Parcels G+H

DESIGN REVIEW REVISION

February 09, 2022

CAMBRIDGE PLANNING BOARD COMMENT

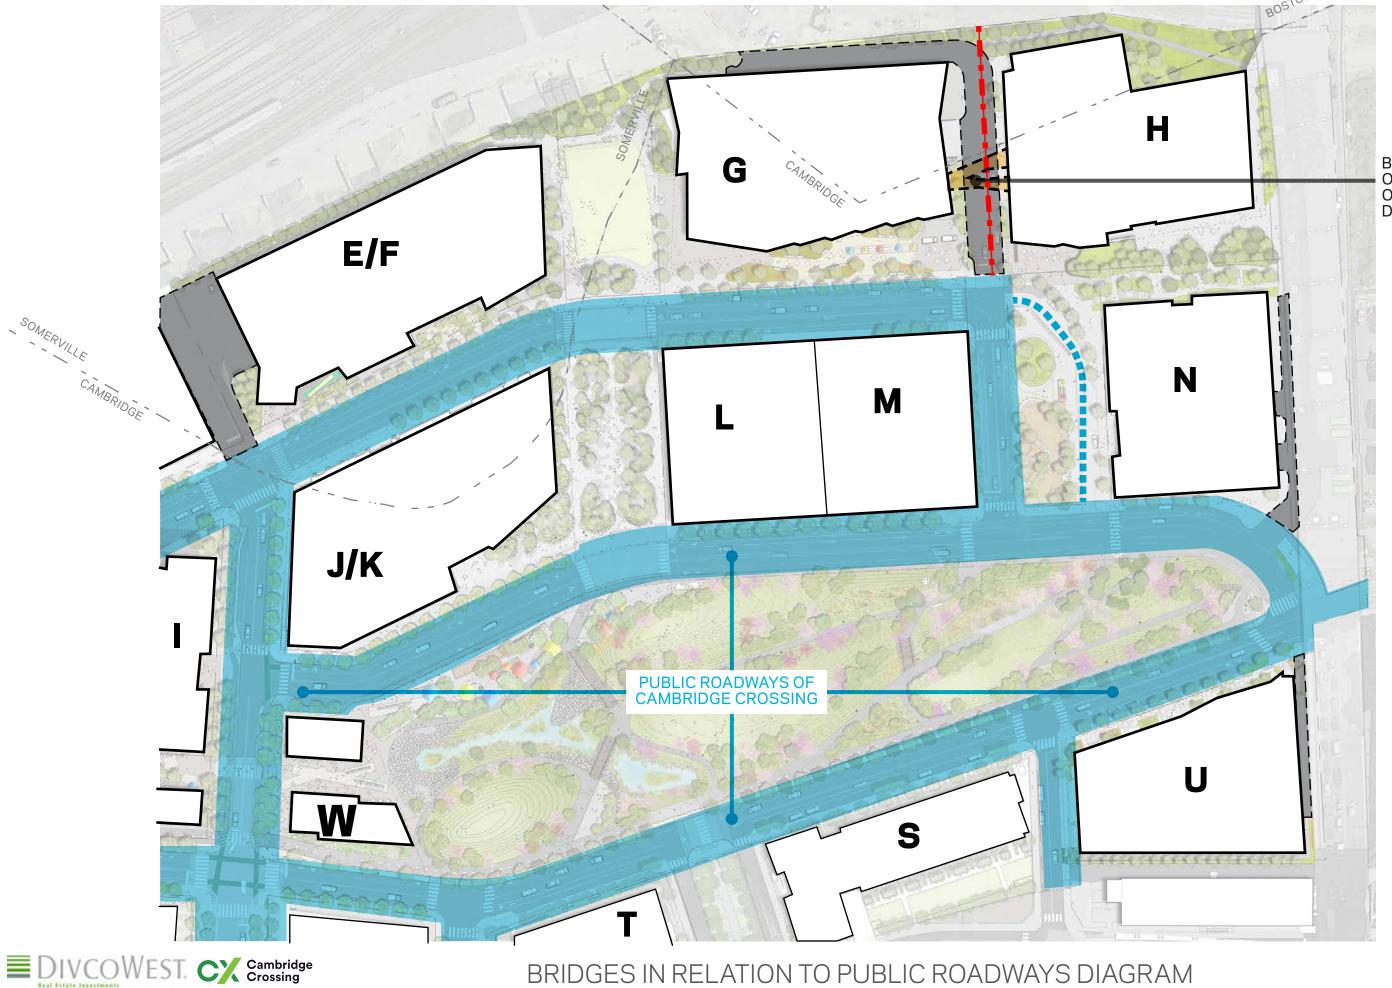
- 1. Provide bridges with distinctive character unique to Cambridge Crossing
- 2. Where the bridges meet G and H, respond to the particular conditions of each building
- 3. Make the bridges appear lighter / more transparent with thinner spandrels / lighter structure
- 4. Provide further information regarding pedestrian wind analysis

- 1. Bridge has distinctive shape and structural system
- 2. Bridges join buildings at curtainwall joints
- 3. Final wind condition better than previously-approved
- 4. Structual and spandrel depths are thinner

Image 1: Wind Conditions Comparison - September 2017 and July 2021

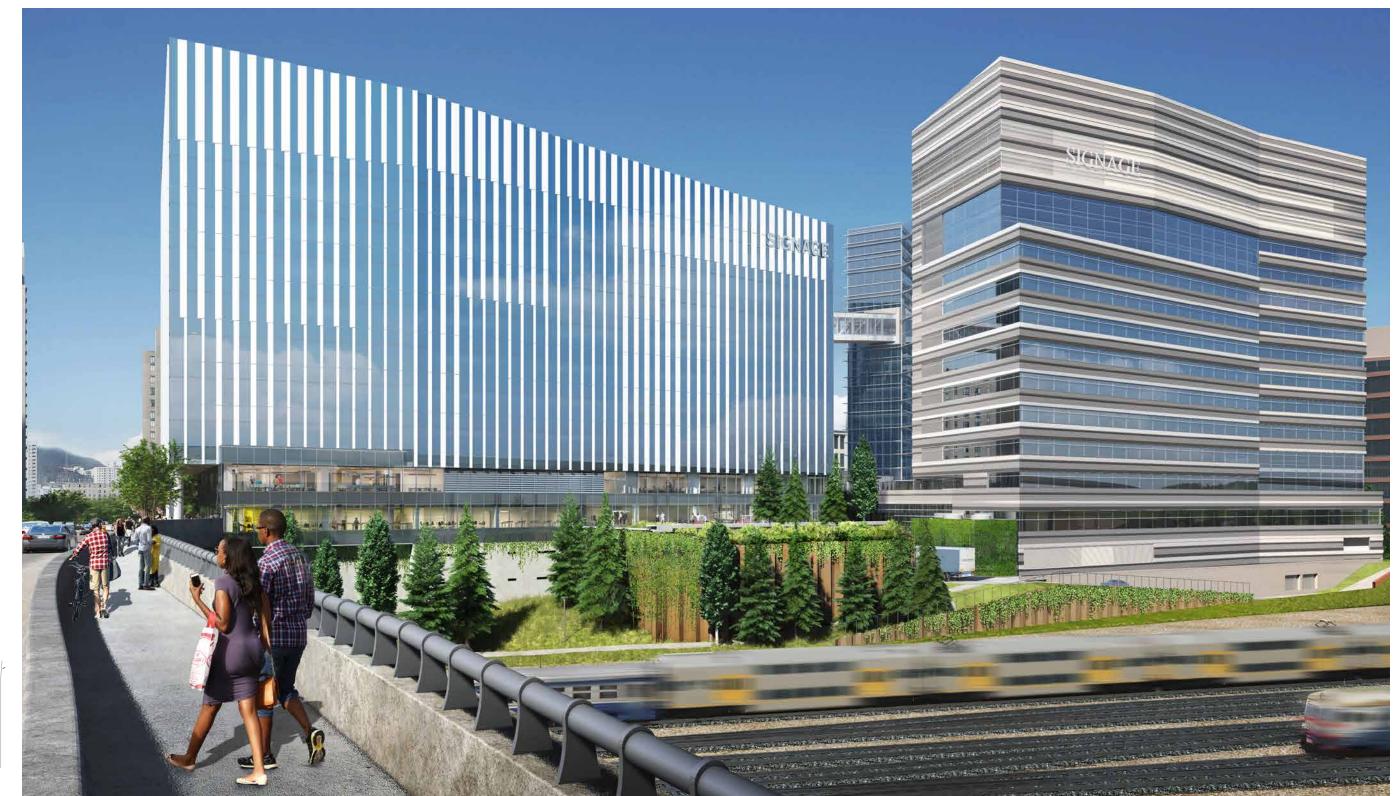
The initial wind tunnel test was conducted in September 2017, followed by a new wind tunnel study in July 2021 with revised building massing and added landscaping. As a result of revised building massing and of landscaping elements, wind conditions at grade level are expected to be improved at most areas for the updated massing, as shown in Image 1. In particular, uncomfortable conditions observed at the area between Parcels G and H are mostly eliminated, while improve conditions are also predicted at the areas to the north of the two parcels.

Image 3: Wind Tunnel Test Model and Updated Bridge Design

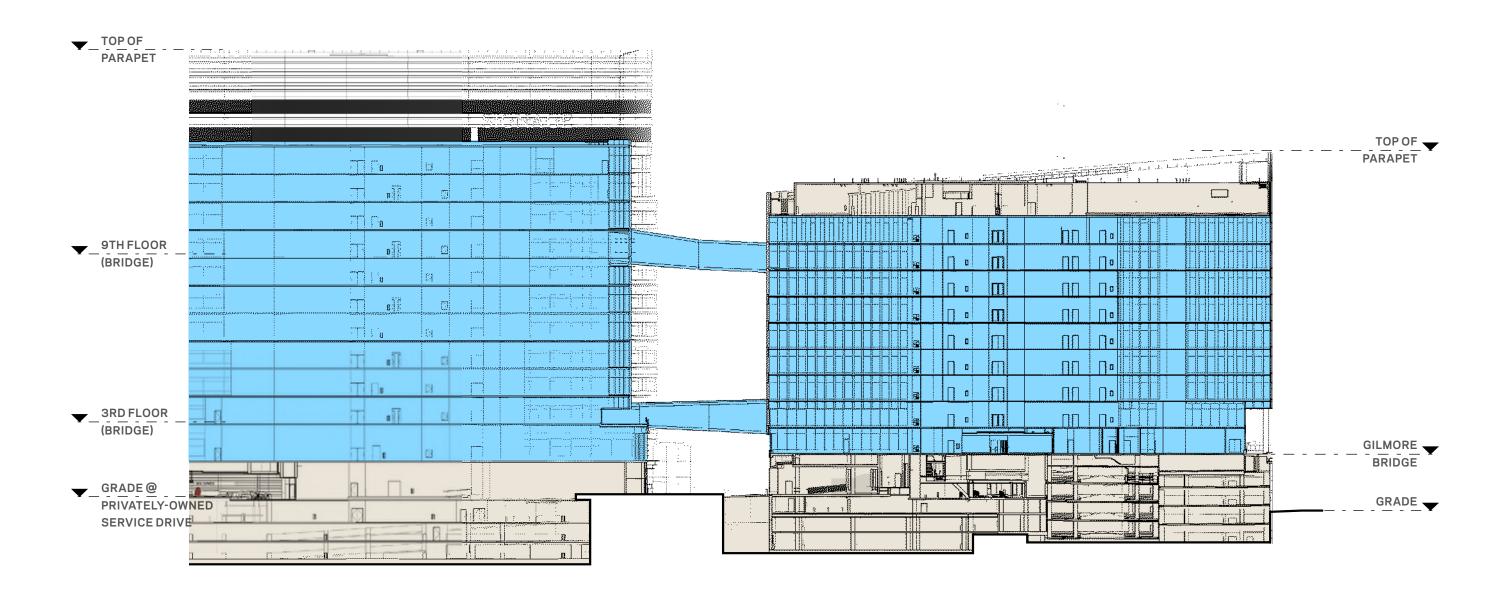
It is our understanding that the design of the two bridges connecting the two parcels have been updated since the latest wind tunnel test, as shown in Image 3.

The elevation of these bridges has not changed in the updated design. The most significant change is the shift of the bridges to the south, as shown in Image 4. This design update is not anticipated to have a significant impact on the wind conditions at grade level. Wind conditions on and around the project site are expected to remain similar to those predicted during the last wind tunnel test.

The latest design of the pedestrian bridge is not expected to influence the results and conclusions presented in RWDI's reports issued in July 2021. Furthermore, the local topography change north of the project area are not expected to impact RWDI's results.
